Terminal Tractor Service Bulletin

Subject: START REGEN switch in QSB Tier 4 Final engines			
Product: Medium Terminal Tractor	Bulletin # SB15T10044	Date: October 27, 2015	Pages: Page 1 of 1
To: All Kalmar Sales Companies		From: Medium Terminal Tractor Product Support

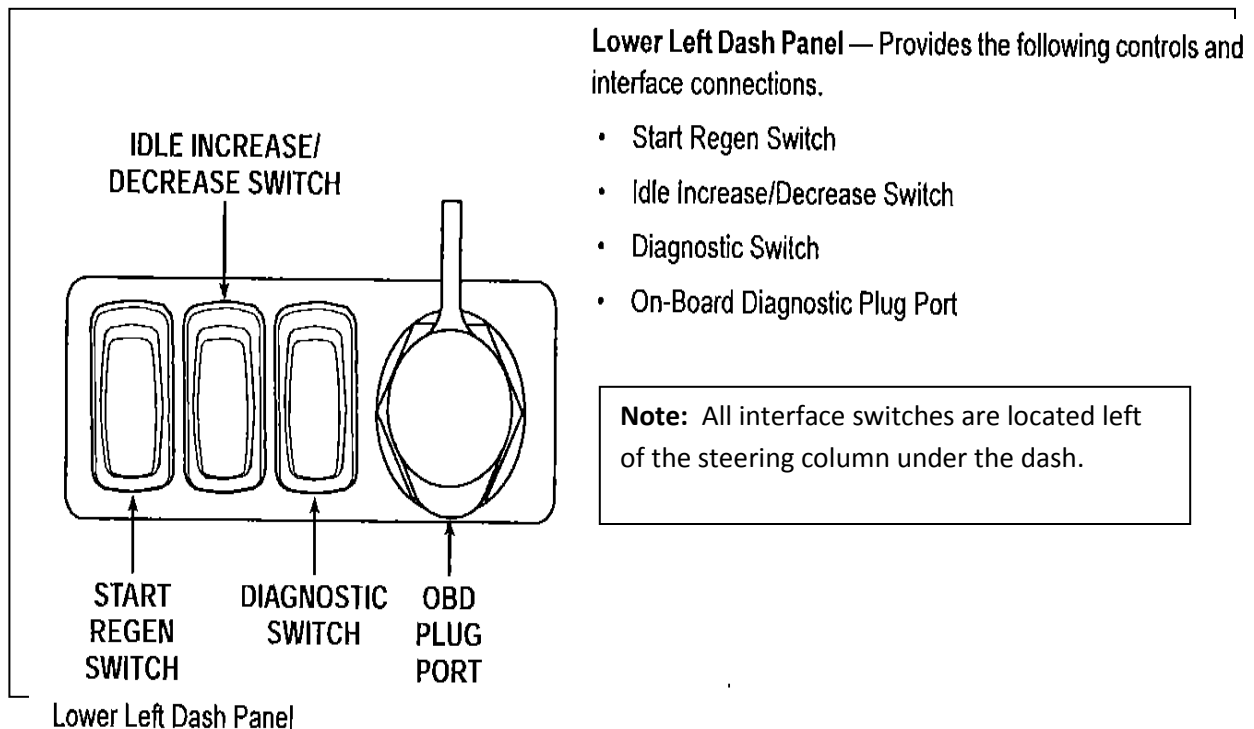
Possible Situation: Units may be missing the START REGEN switch, part number CTT00002129.

See attached photo. The "Start Regen" switch is located on the left of this panel.

Solution: Inspect units equipped with the QSB Tier 4 Final engines. If the switch is missing order part number CTT00002129 and install. The truck is already wired for the switch.
